STM TripModifications

Detours whose cancelled range is shorter than the detour itself

Feed timestamp 1788730587 (2026-09-06 17:36 America/Montreal) · 125 entities examined · 8 repaired

Route 10: cancelled range [1..1] should be [1..3]

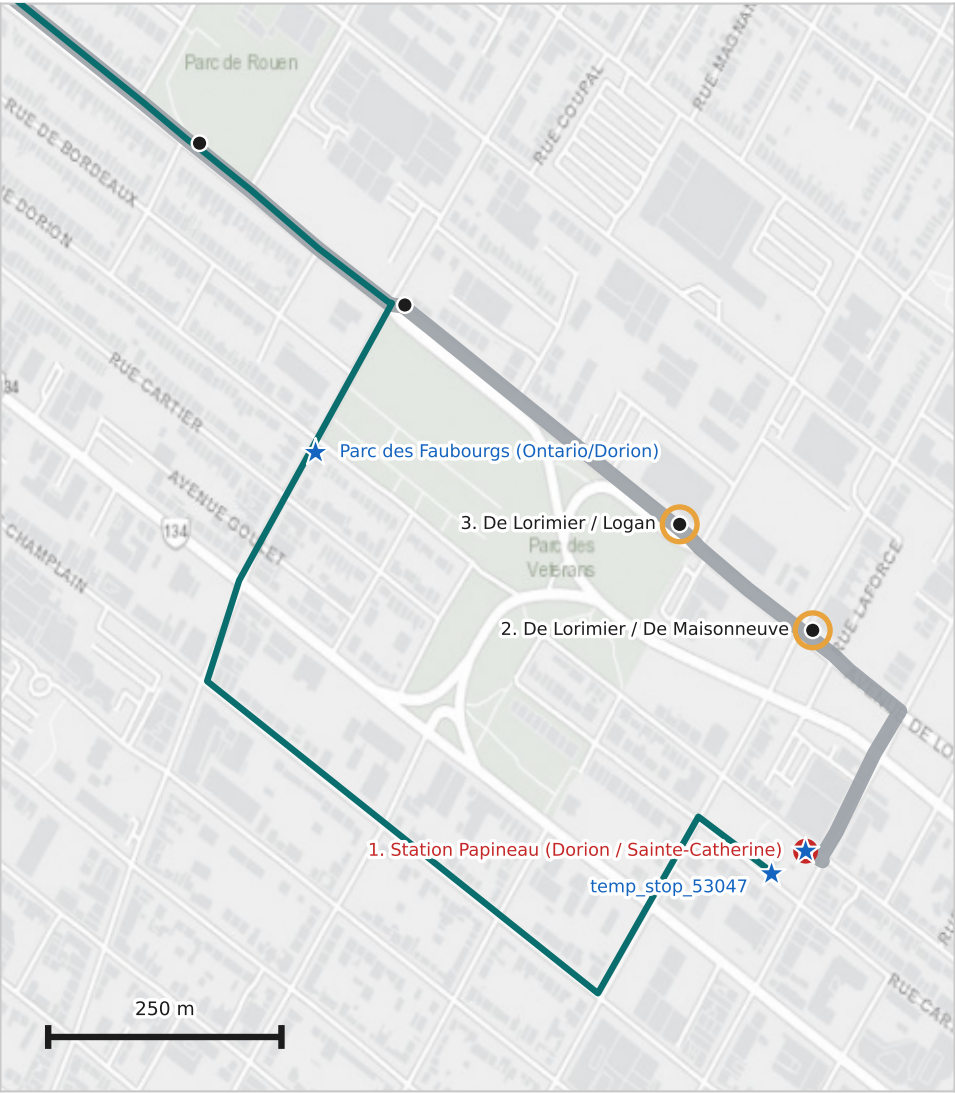
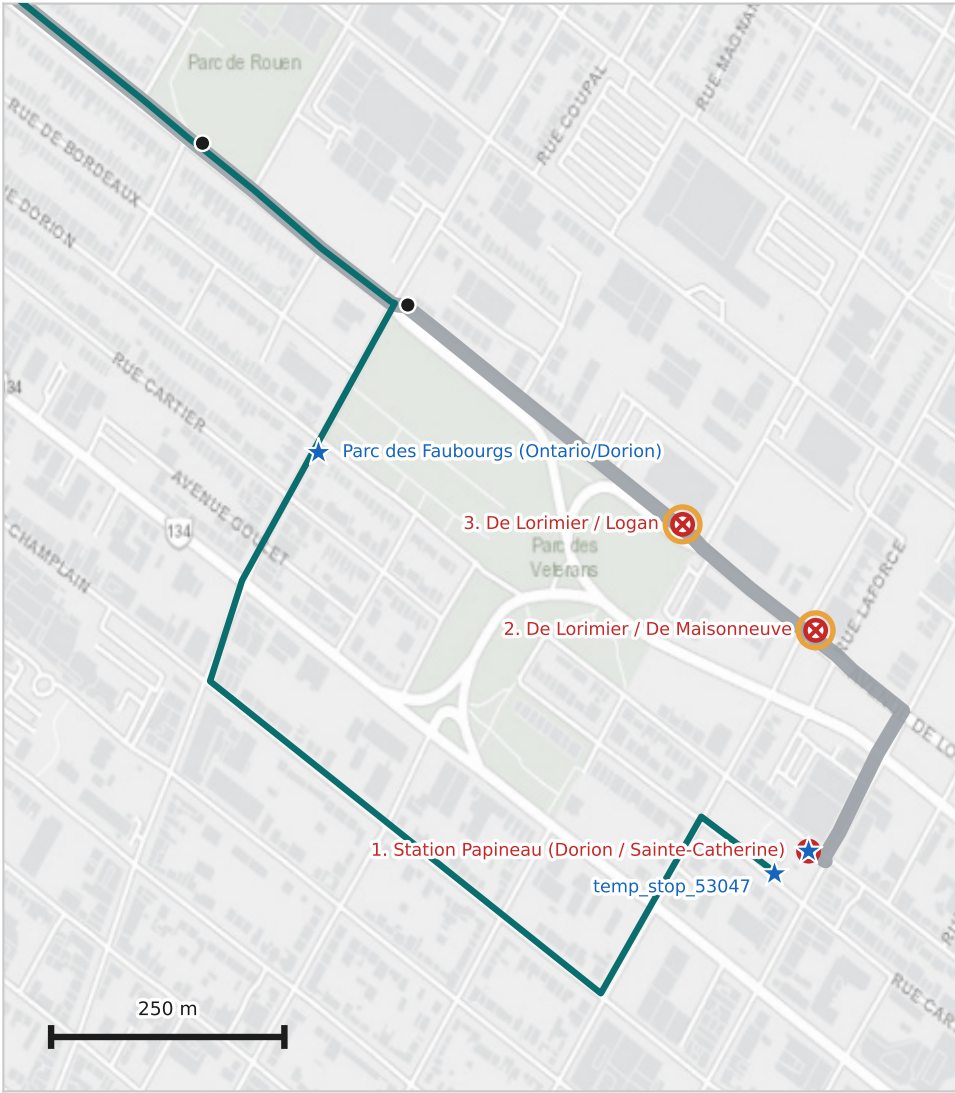
2 stops kept in the trip sit up to 262 m from the detour shape.

Route 11: cancelled range [24..29] should be [23..29]

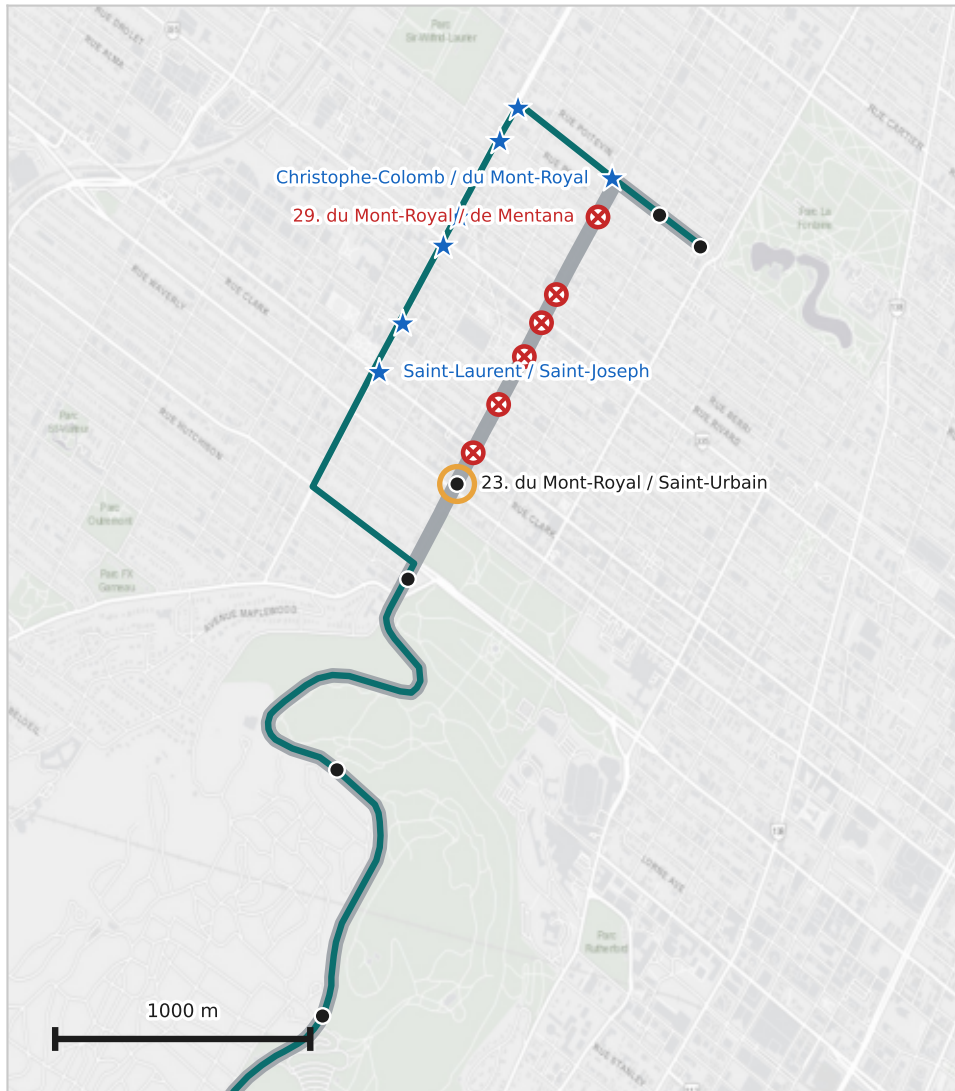
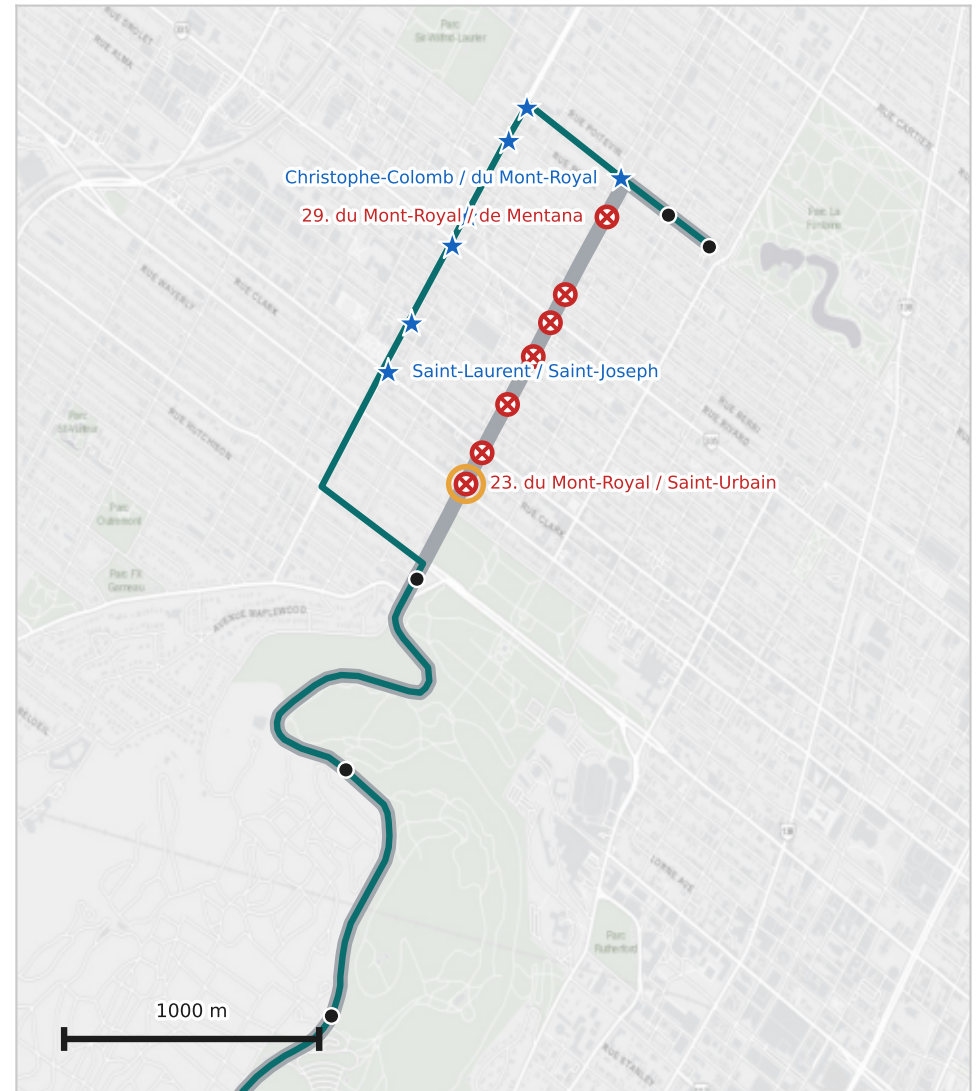
1 stop kept in the trip sits up to 309 m from the detour shape.

Route 166: cancelled range [37..37] should be [32..37]

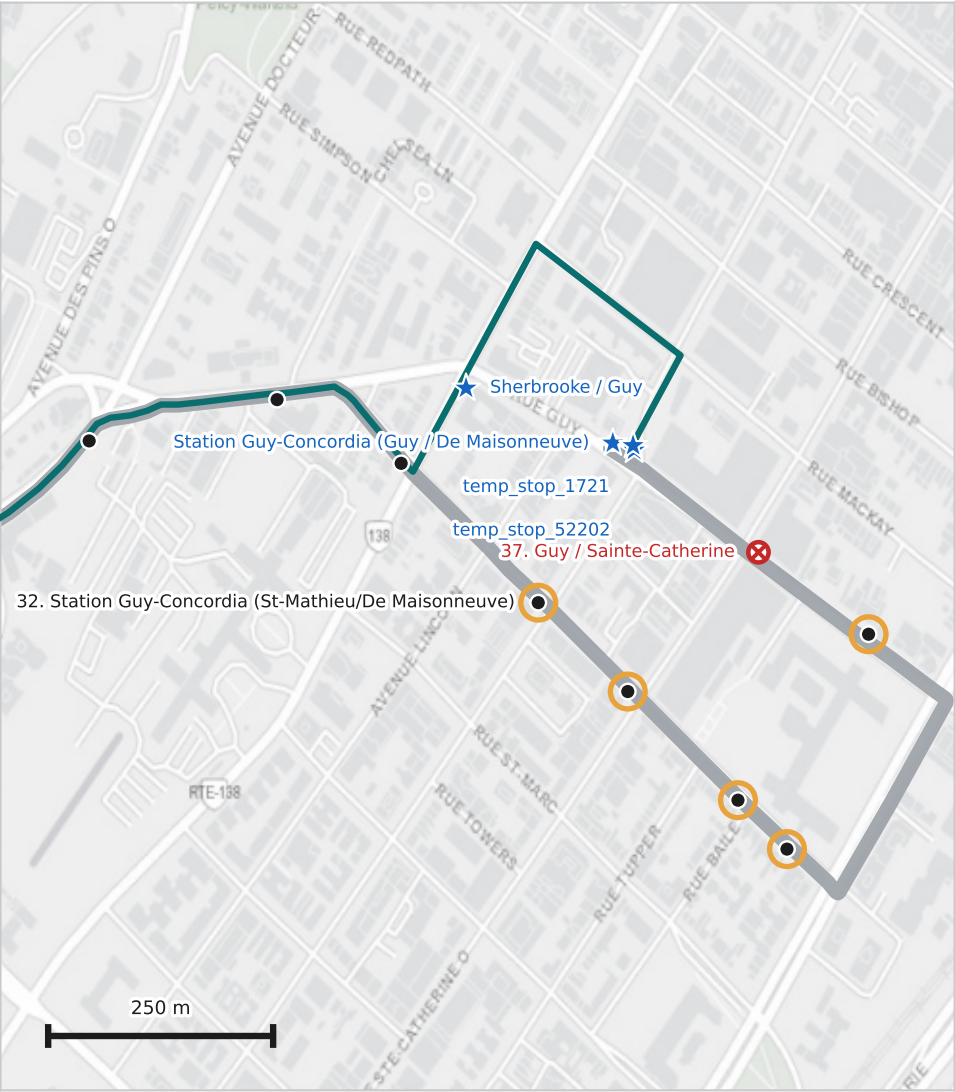
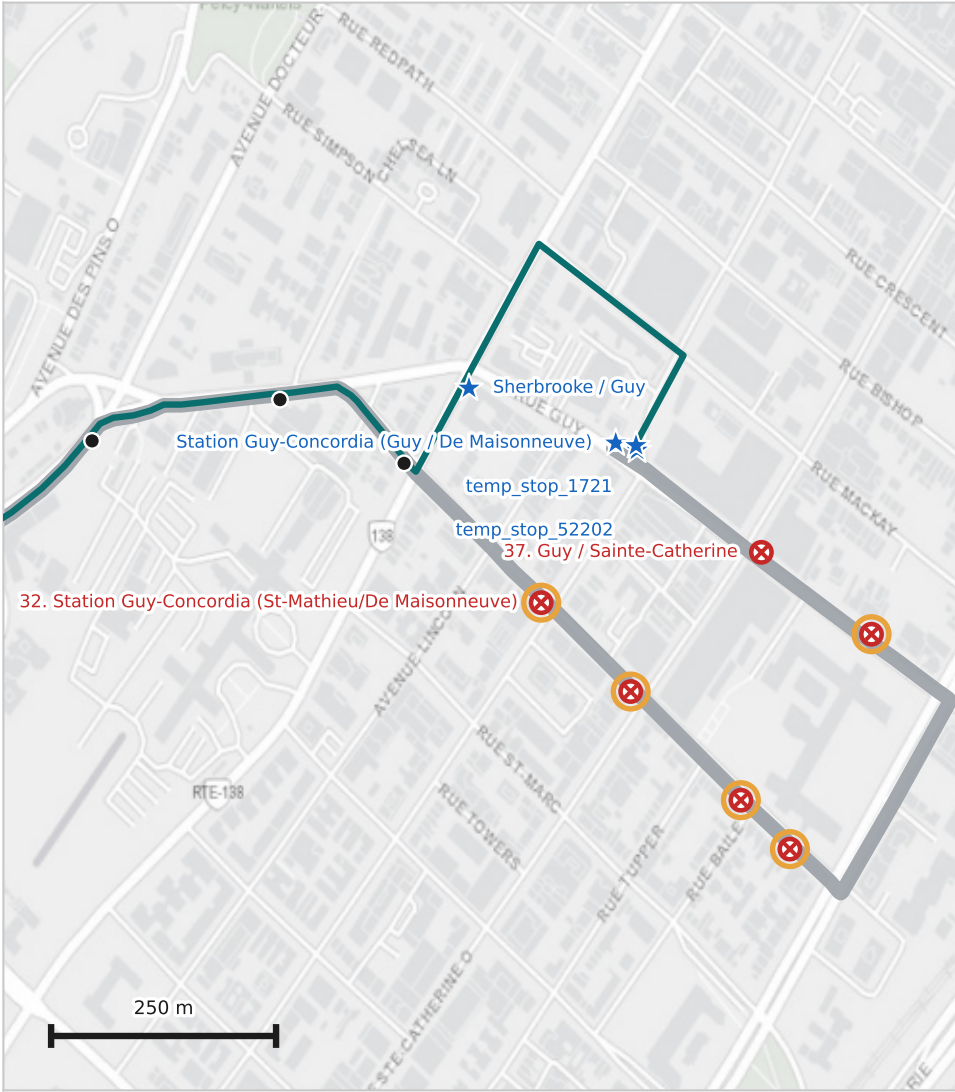
5 stops kept in the trip sit up to 412 m from the detour shape.

Route 50: cancelled range [14..14] should be [14..15]

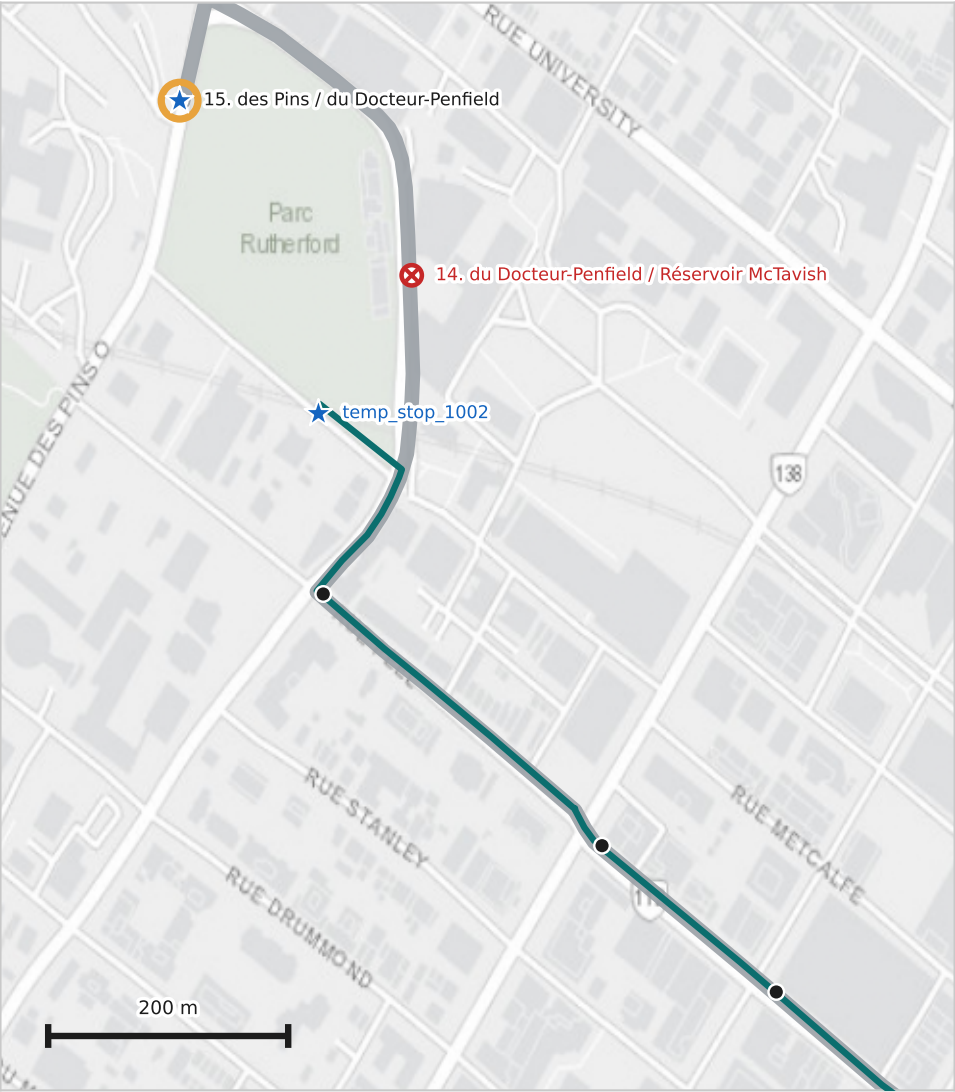
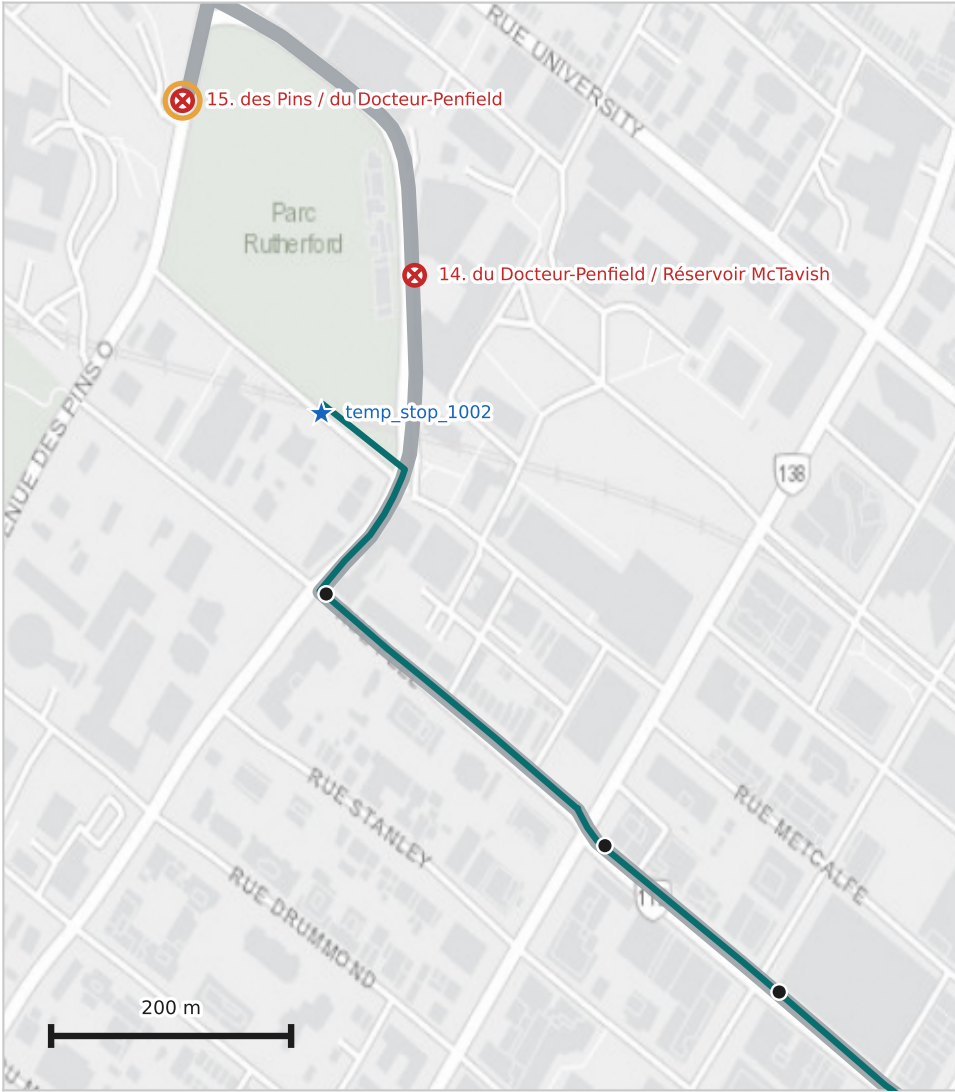
1 stop kept in the trip sits up to 241 m from the detour shape; replacement stop 54346 is 241 m from it.

Route 97: cancelled range [35..35] should be [19..35]

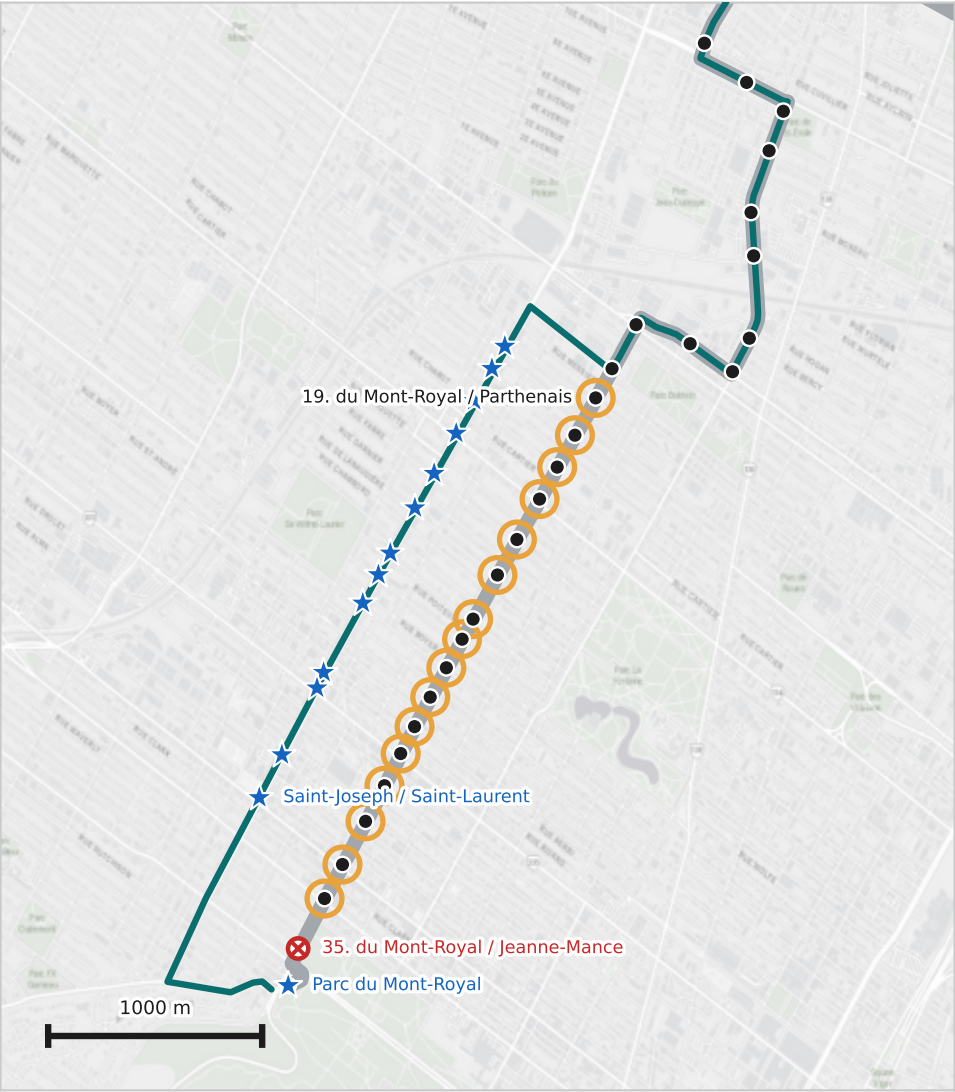
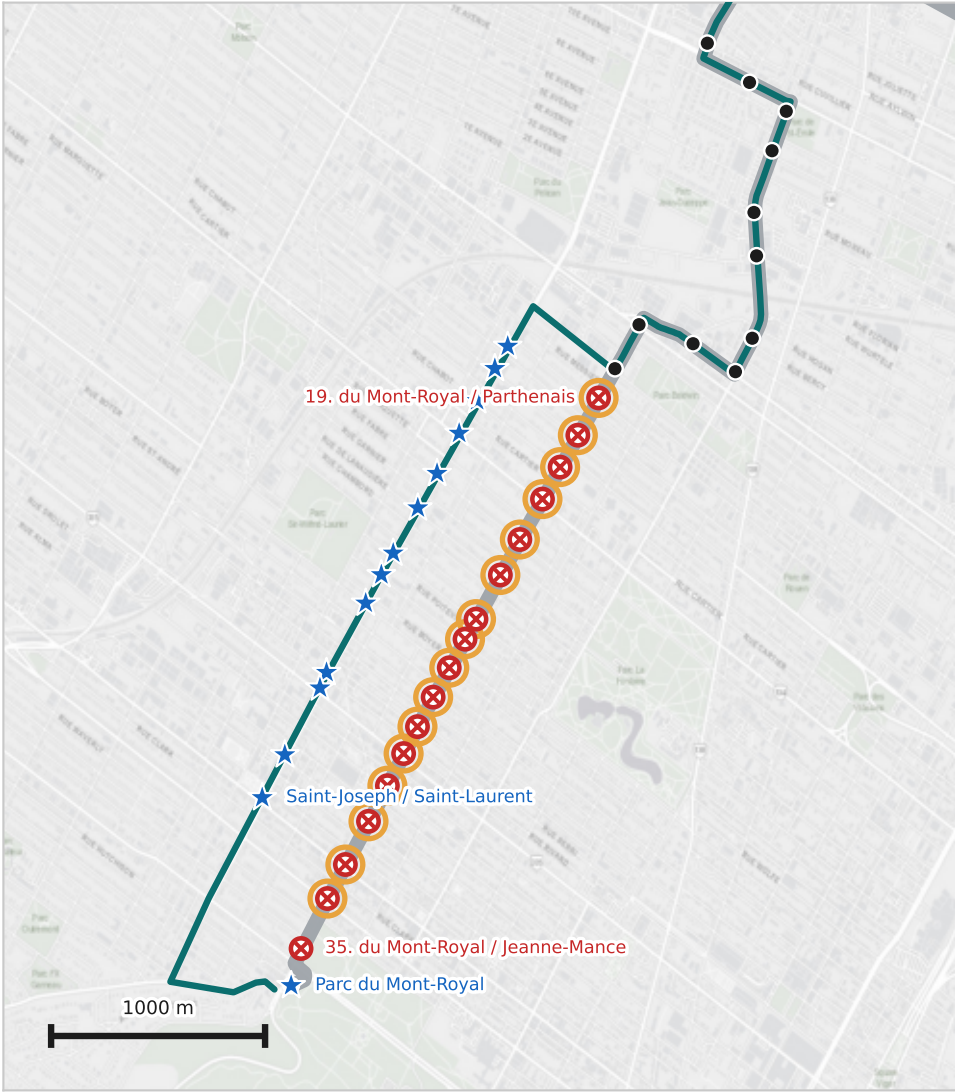
16 stops kept in the trip sit up to 471 m from the detour shape.
